Subject: USNRC Docket No. 72-1014, TAC L23082
HI-STORM 100 Certificate of Compliance 1014
NRC Letter, C. Jackson, to B. Gutherman, Holtec, dated July 16, 2001

References: 1. Holtec Project 5014
2. HI-STORM License Amendment Request 1014-1, Revision 2

Attachment: Copy of Figure 3.2.3-1 from HI-STORM Certificate of Compliance 1014

Figure 3.2.3-1
HI-STORM OVERPACK Dose Rate Measurement Locations

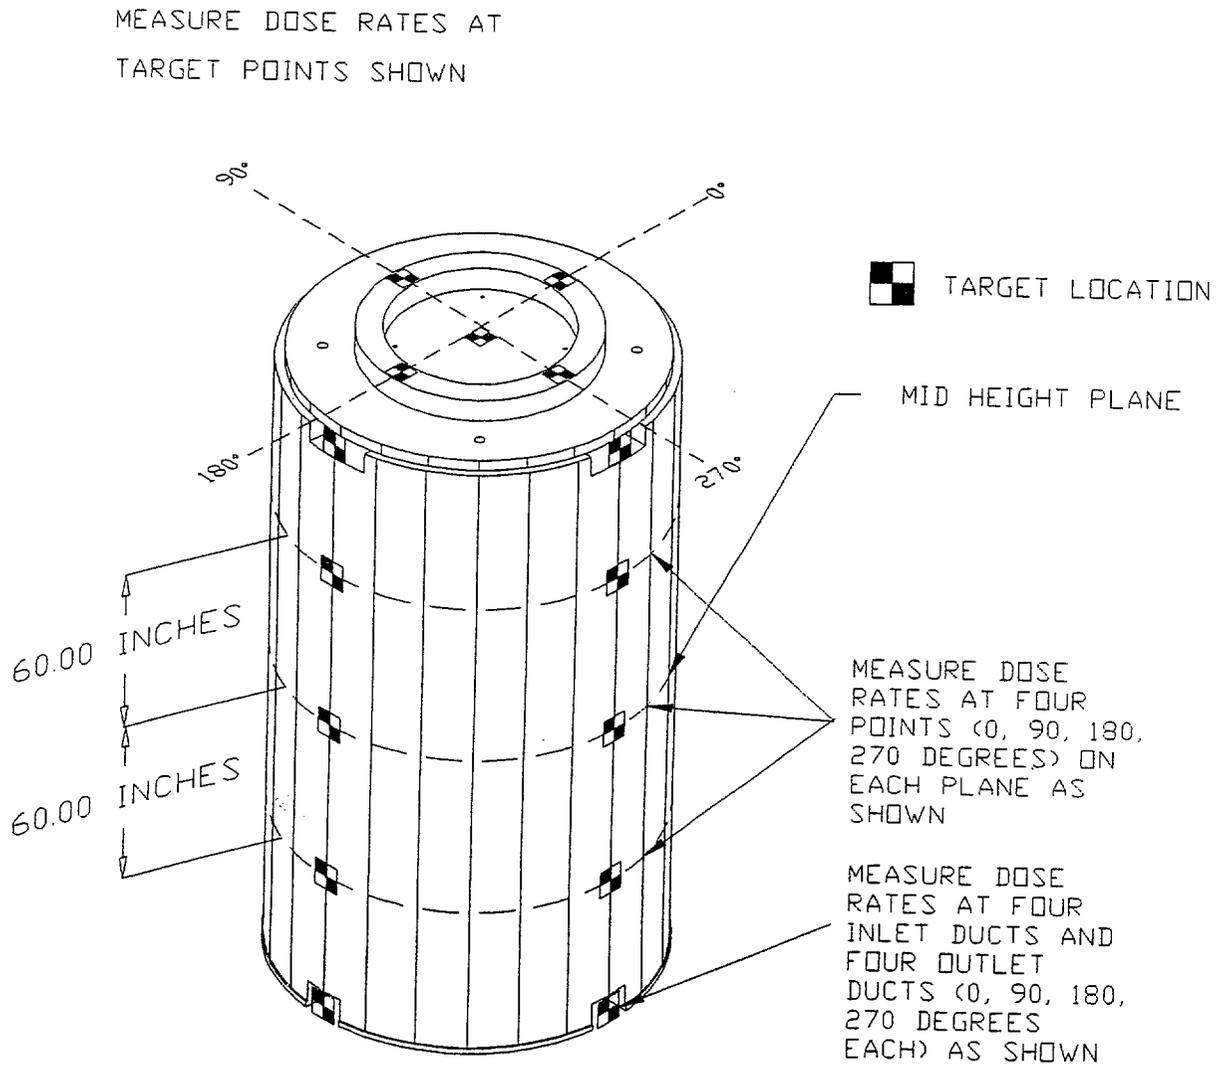
We thank the Spent Fuel Project Office for communicating with us on the matter of the statements with regard to the 10CFR 72.48 process made in our July 3, 2001 submittal in response to NRC's RAIs on LAR1014-1. We believe that the concern with regard to our implementation of the 10CFR 72.48 process arises from a misunderstanding of our position and a misconstrual of the materiality of the facts relative to Figure 3.2.3-1 in the HI-STORM Technical Specifications (see attached).

We, as well as our client, Entergy Nuclear Northeast, have carefully evaluated the technical information in Figure 3.2.3-1 (hereinafter called the Figure). From our evaluation we concluded that the technical information specified in the Figure seeks to identify the approximate locations of twenty five target points for dose measurement, as follows:

1. Dose measurements are required on both sides of the overpack in each of the two vertical planes, at five discrete locations, namely, at mid-height, 60" above and below the mid-height and at the top and bottom vent locations.

2. Dose measurements on the top surface of the lid are also required in the same two orthogonal planes at mid-radii and finally, at the center of the lid.

Surveillance Requirement 3.2.3.1 states that dose rate measurements shall be taken at the locations shown in Figure 3.2.3-1. To identify the target locations, the Figure utilizes a pictorial representation with an array of parallel vertical and circumferential lines forming a grid system that bear no correspondence to the actual hardware other than to illustrate the relationship of the cask and the grid system. Indeed, the Figure, drawn to no scale or a particular drafting practice, is a 3D illustrative model and entirely indeterminate with respect to the anatomical details of the cask. For example, the final storage configuration is not accurately depicted since the gamma shield cross plates and the ventilation screens, which are required, are not represented. However, such indeterminacy in physical details of the HI-STORM shown in the Figure does not bear on the ability of users to comply with the LCO, which establishes only a dose rate limit "at the inlet and outlet air ducts" wherever they may be located. This position is also consistent with the Bases, SR 3.2.3.1, for this technical specification surveillance requirement in Appendix 12.A of our HI-STORM FSAR which states: "Measurements at approximate locations to those shown on Figure 3.2.3-1 are acceptable." In summary, the information in the Figure is *technically precise with respect to the requirements it seeks to illustrate*. We respectfully submit that an attempt to define the geometric details of the overpack from a not-to-scale 3D illustration would lead to misconstrued conclusions.
